City of Avondale Estates
Historic Preservation Commission
COA Application Review*

February 2, 2026 HPC Meeting

Property Address: 72 Dartmouth Avenue

Project Summary: The proposed project for this 1941 American Small House consists of (1) removal of a double-hung window on the south side elevation and replacement with two new windows; (2) infill of the side entrance stoop and door on the south side elevation; and (3) construction of an addition to the master bath and bedroom on the east rear elevation.

Figure 2 - Window to be removed and replaced with 2 windows. Door and stoop that will be filled in and replaced with brick to match surrounding wall:

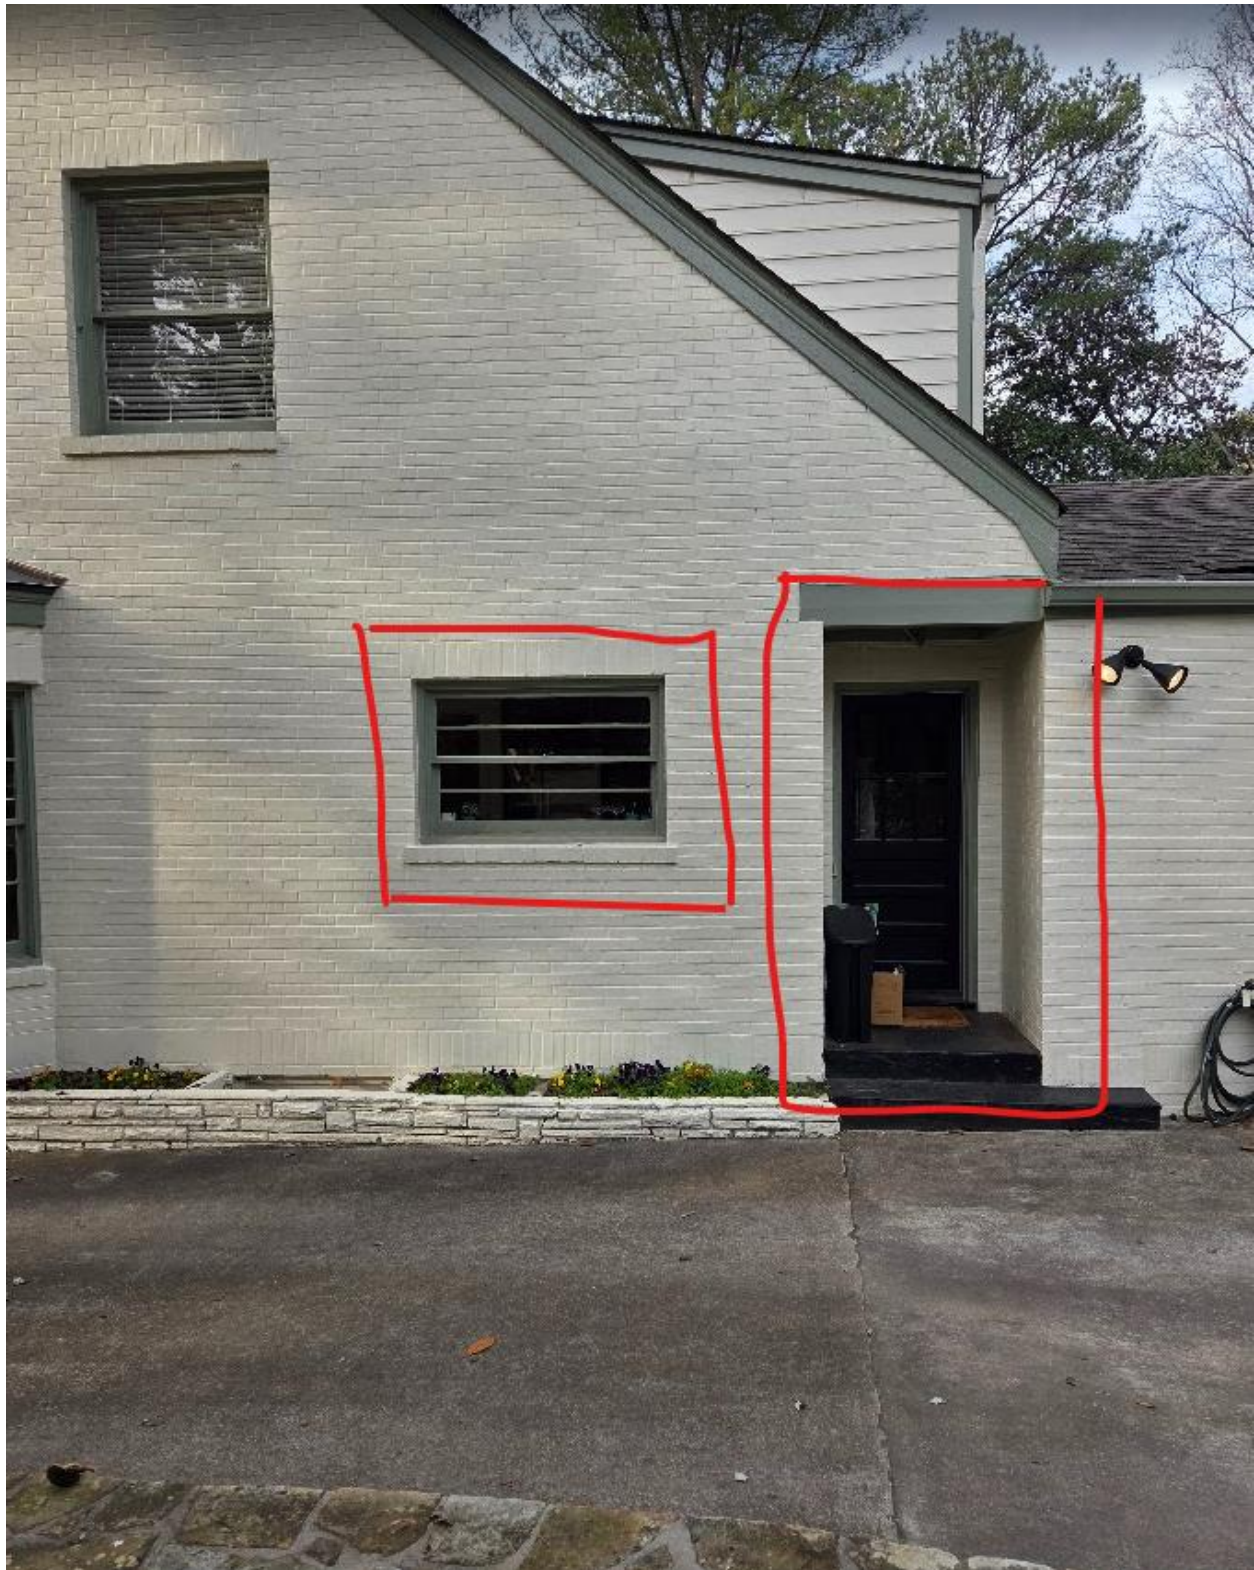
The *Guidelines* also state that new openings are not allowed on the front or sides of a *Preservation Designation* house. New openings on the rear elevation are allowed. Based on the *Guidelines* and previous approval by the HPC, the kitchen window may be replaced in its original location, but infilling the window opening and creating two new window openings is not allowed.

The *Historic District Guidelines for Entrances on Preservation Designation* properties state that all original doors and surrounds shall be protected and maintained and shall not be removed or altered unless they are beyond repair. New door openings are not allowed on the front and side elevations; therefore, infilling an original door opening is also not allowed. Rather than infilling and eliminating the side entrance stoop and door, these original side-elevation elements should be left in place. The exterior door can be covered over from the interior. An option for partially infilling the stoop but leaving the stoop opening visible might be considered.

- The kitchen window opening should not be infilled, and new window openings should not be added on the side elevation.

- The kitchen window should be replaced in its original opening. The replacement window should have rails, stiles, and muntins that match the dimensions of the existing window. SDL sashes must include a spacer between each muntin.
- The side entrance stoop and door should not be removed and infilled, but should be left in place and the door covered from the interior. An option for partially infilling the stoop but leaving the stoop opening visible might be considered, but must be approved by the HPC.
- The rear addition should have a visible juncture to distinguish it from the original house, such as a slight wall setback or seam in the brick veneer.
- Total lot coverage with the new addition should not exceed 40%.

Figure 5 – Small extension to provide more square footage and provide room for the door to the new bathroom

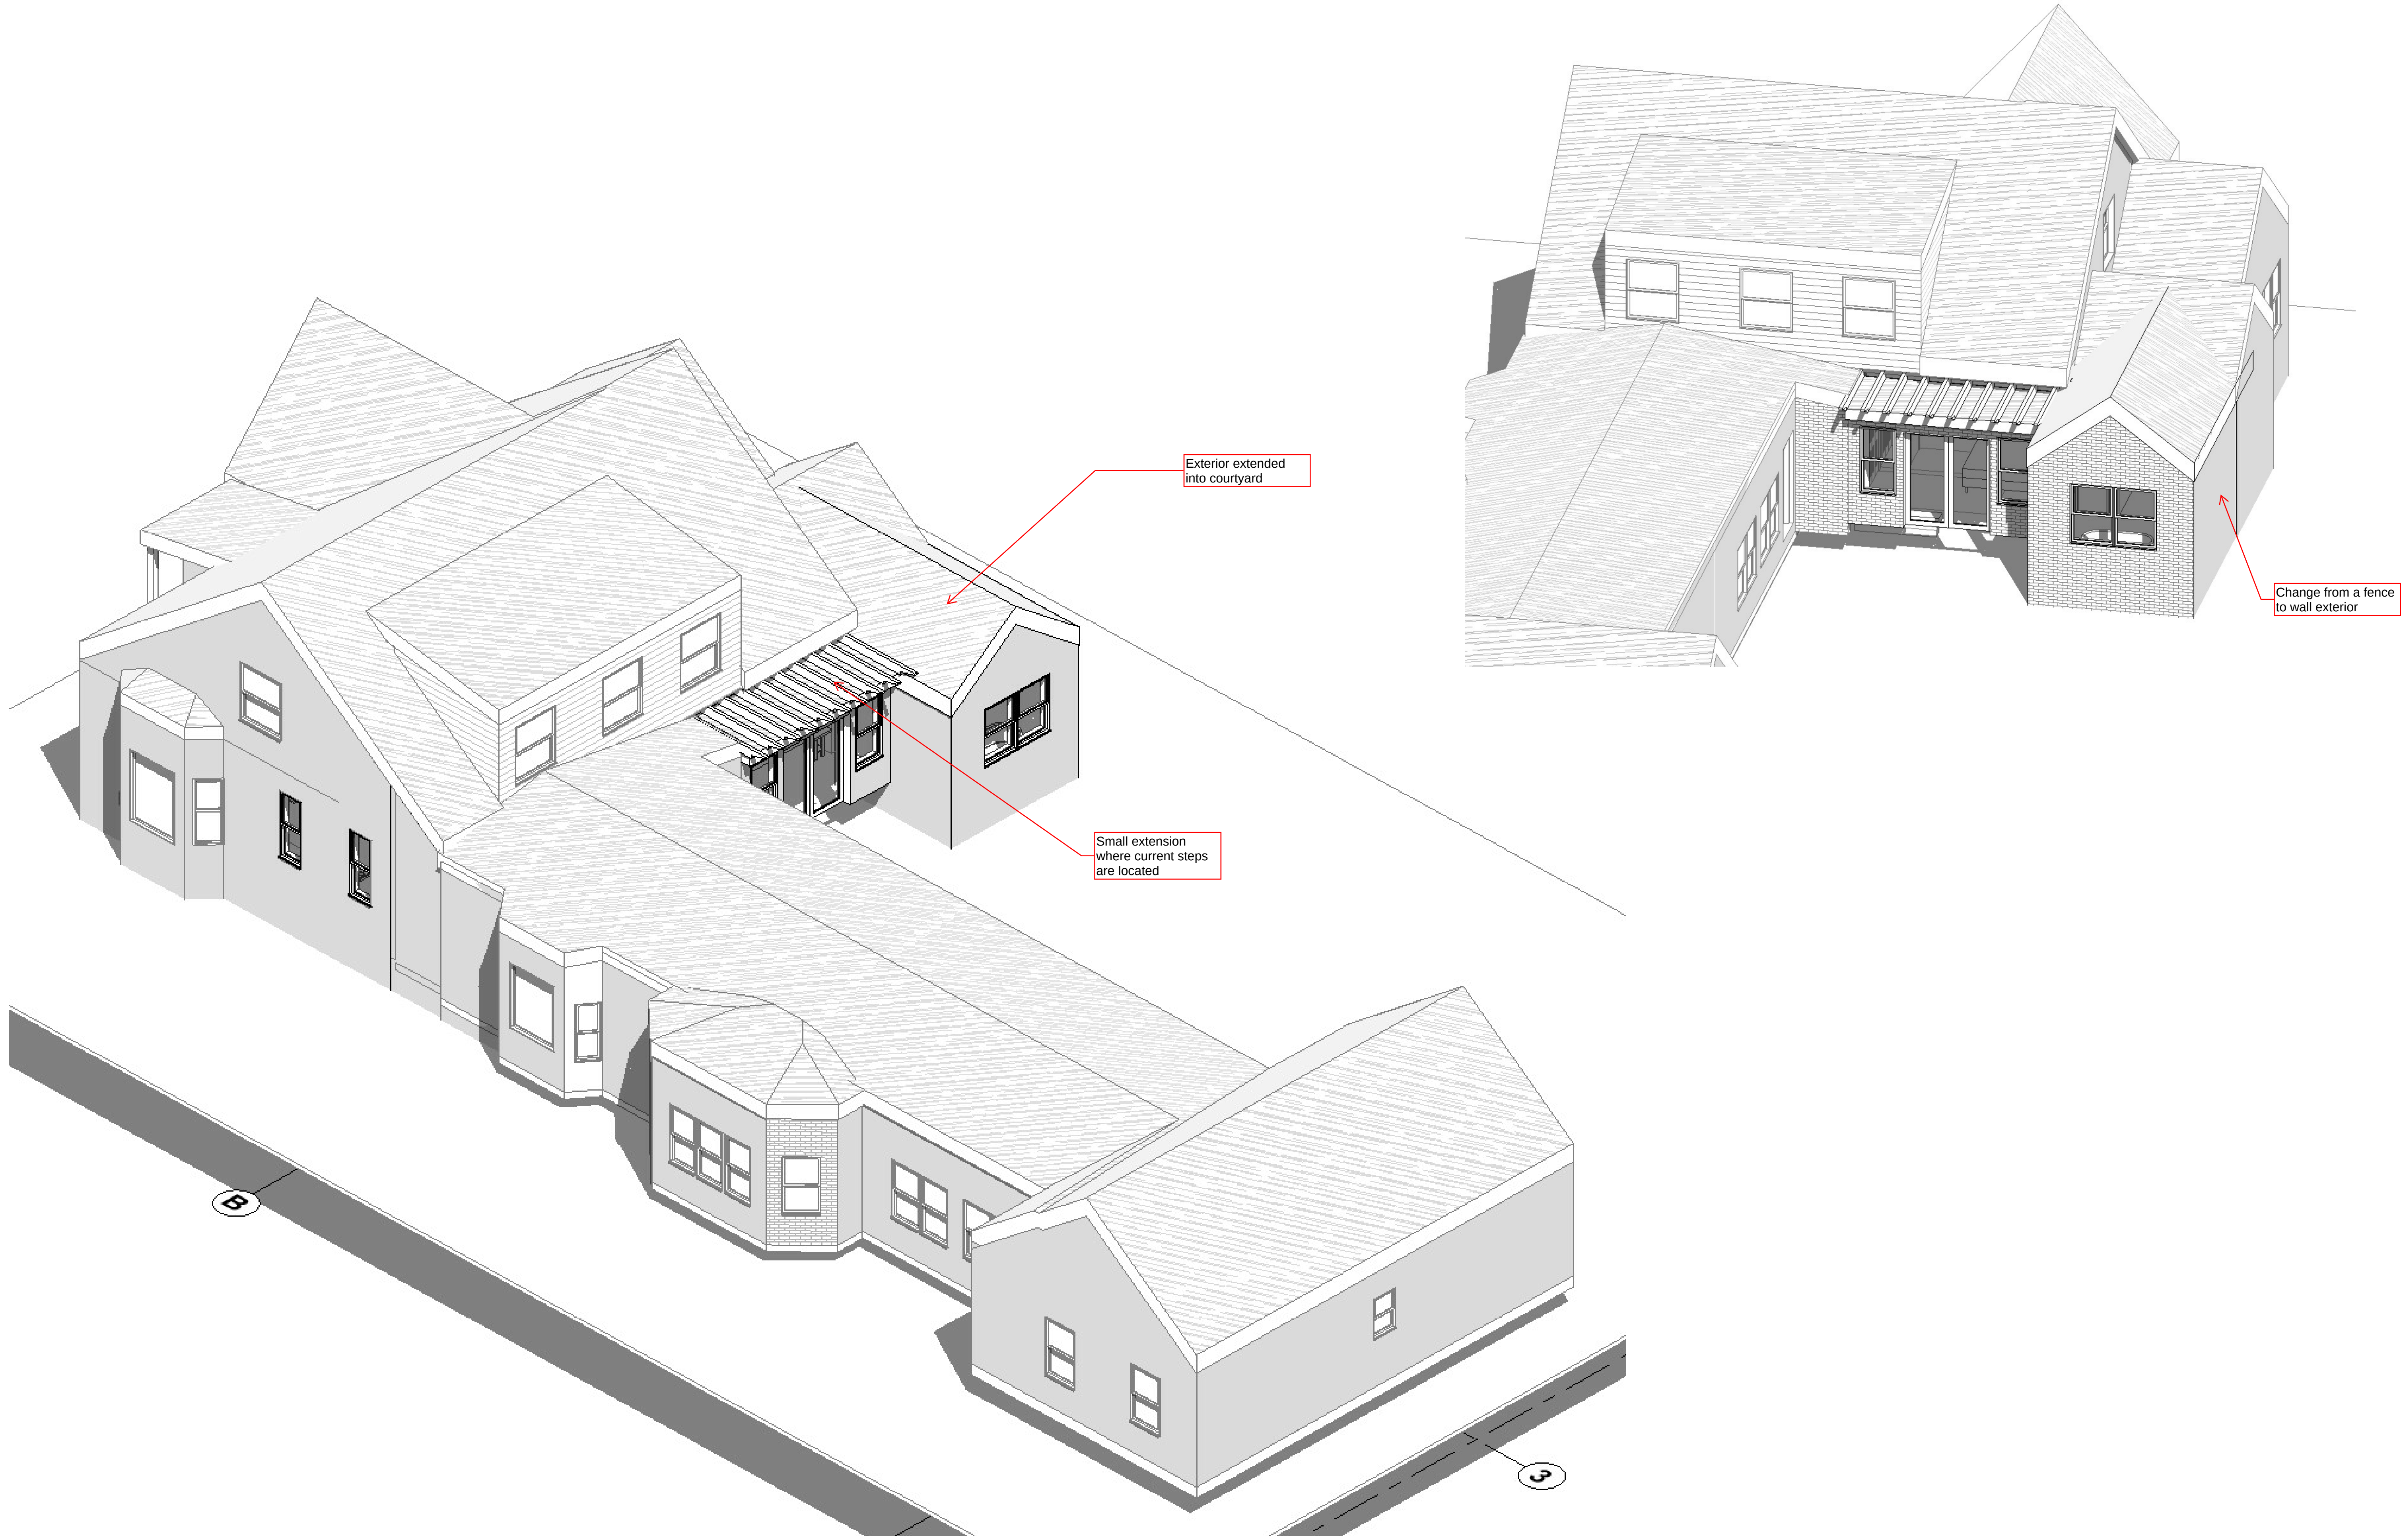
The *Historic District Guidelines for Additions on Preservation Designation* properties state that additions shall be limited to rear elevations and the rear half of side elevations of the primary structure. Additions shall not exceed an 80% increase of the house's original footprint, and roof and floor elevations shall not exceed those of the main house. Additions shall be constructed of materials found on the primary structure, and a visible juncture shall be provided between the new and existing. Lot coverage with the addition shall not exceed 40%.

The proposed 211-SF addition will be located on the house's rear elevation. Its small size is well below the allowed 80% increase, and its roof ridge is well below the main roof and other side-gabled roofs. The addition will be finished with painted brick veneer found on the existing house. A visible juncture, such as a slight wall setback or seam in the brick veneer, should be provided to distinguish the addition from the existing house. Lot coverage with the addition should be provided to the HPC to ensure it does not exceed 40%.
